28 July 2025

Development Application No: DA2025/0750 for Alterations and additions to a dwelling house including a swimming pool at 31 Cook Terrace MONA VALE.

Figure 1: Proposed building height

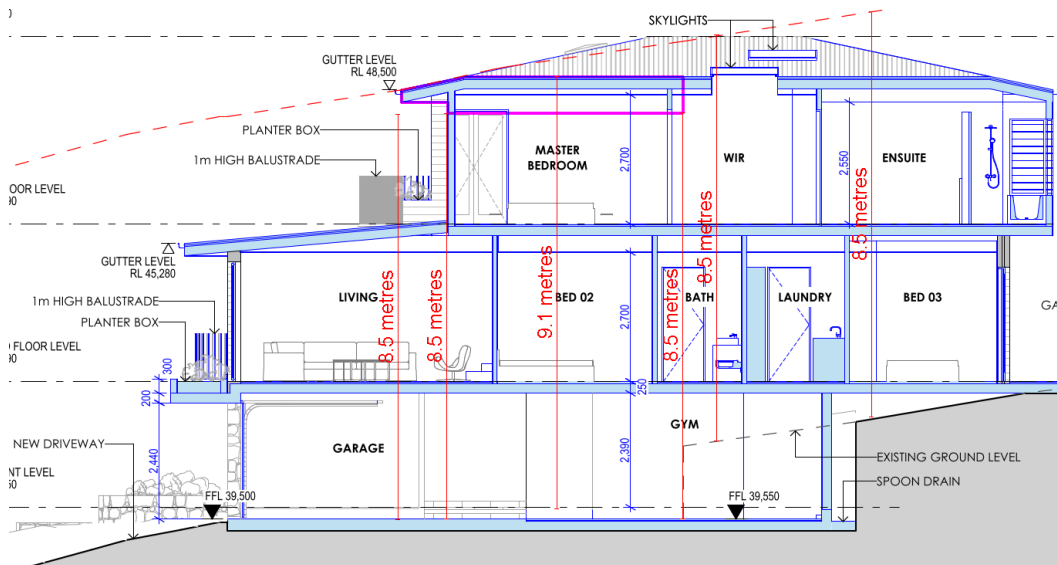
Clause 4.3 of the Pittwater Local Environmental Plan 2014 stipulates that the height of a building on the site is not to exceed 8.5m measured from the existing ground level. The submitted Clause 4.6 request states that the development has a maximum building height of 9m. However, the true maximum building height is unclear given the existing ground level is not shown on the section plan across the entire footprint (refer Figure 1 below). The architectural plans shall therefore be amended to clearly show the existing ground level on all section plans.

Figure 3: Existing street view (31 & 29 Cook Terrace)

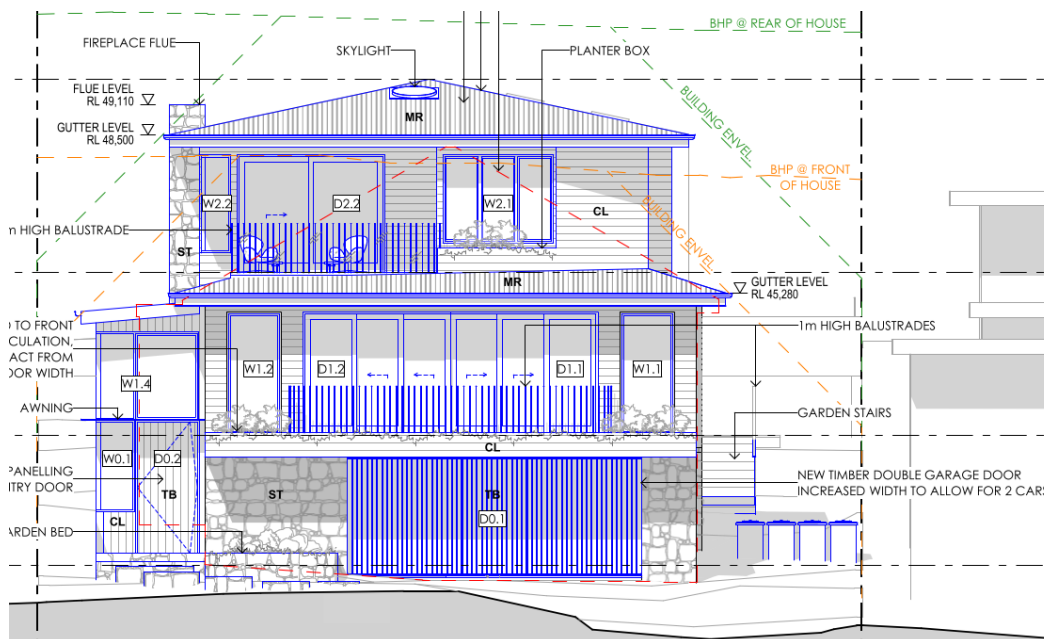
The submitted Clause 4.6 request argues that the proposed development will have a height and scale that is commensurate with the adjoining dwelling at 29 Cook Terrace. However, the proposed dwelling presents as three storeys from the streetscape with a roof ridge height of RL 49.62, while the neighbouring dwelling presents as a two-storey development from the streetscape (albeit having a three-storey stepped built form) with a parapet height of RL 47.34 (refer Figures 2 and 3). As such, the proposed dwelling is not necessarily commensurate with the height and scale of the neighbouring property.

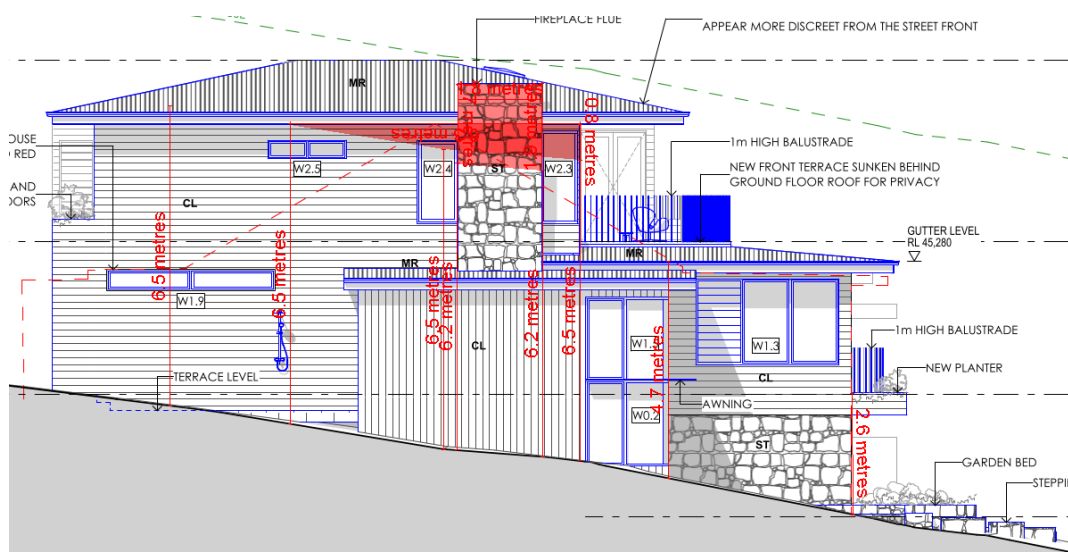
While the upper floor level is set back a minimum of 9.1m from the front boundary, the design and siting of the upper level is not supported in the context of the building height breach, view loss concerns and three-storey built form. The proposed upper floor level shall be set further back from the front boundary to maintain views enjoyed by the neighbouring property at 29 Cook Terrace, reduce the maximum building height, and create a more stepped built form to reduce visual bulk and present less as a three-storey building mass. The building height could be reduced further through potentially reducing the floor-to-ceiling heights of the ground and upper levels.

Figure 4: Proposed NE elevation

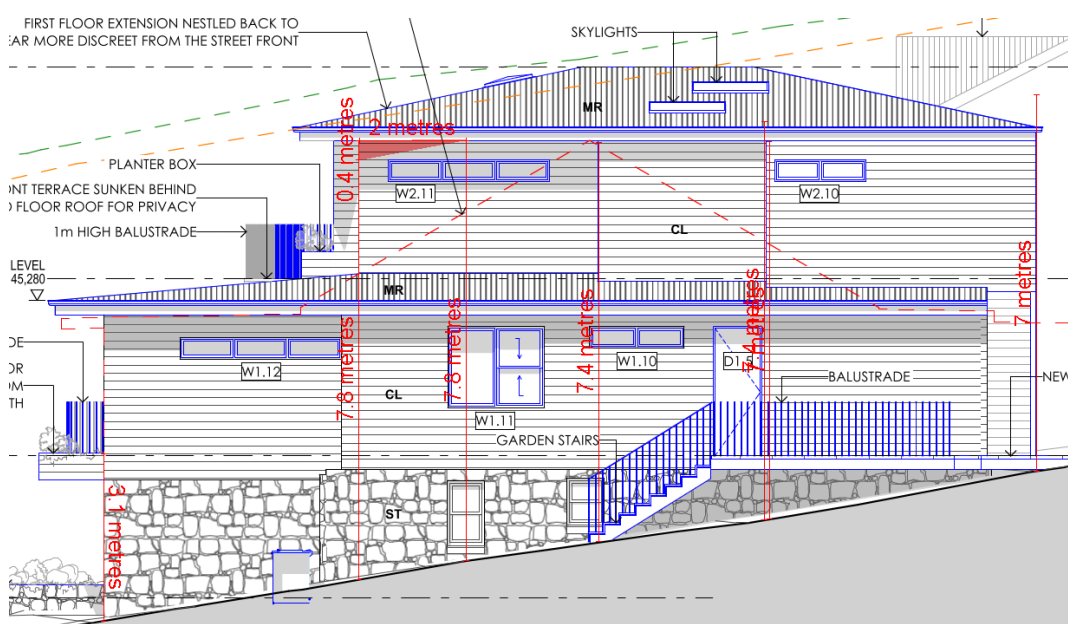
The proposed building envelope at the north-eastern elevation presents an encroachment of between nil and 0.8m in height for a length of 6.3m, and a second encroachment of between 1.7m and 1.9m in height for a length of 1.8m, resulting in a maximum variation of 30.6% (1.9m), as shown shaded red in Figure 4 below.

The Applicant shall amend the proposed design to reduce the degree of non-compliance with the building envelope, particularly at the north-eastern elevation. This would be best achieved by setting the upper floor level back further from the front boundary and ground floor level below, as mentioned in item 5 above, notwithstanding compliance with the minimum front setback.

Figure 6: Ground floor demolition plan

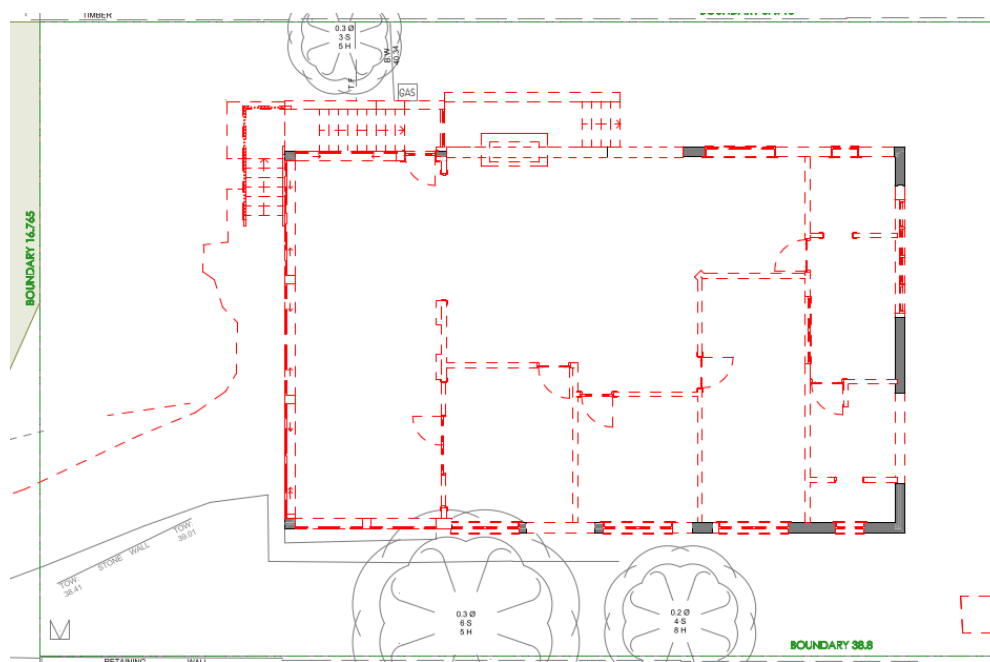
Retaining the existing ground floor level front setback despite no retention of existing walls at this end of the dwelling (refer Figure 6) limits view sharing and the opportunity to reduce the perceived bulk and scale of the development. A more skilful design would involve each floor stepping progressively further back from the front boundary, resulting in a stepped built form that responds to the sloping topography of the site. This approach would better align with the desired character of the Mona Vale locality and assist in preserving views and vistas, given the proposed roof above the ground floor level is likely to obstruct views currently enjoyed by the neighbouring dwelling.
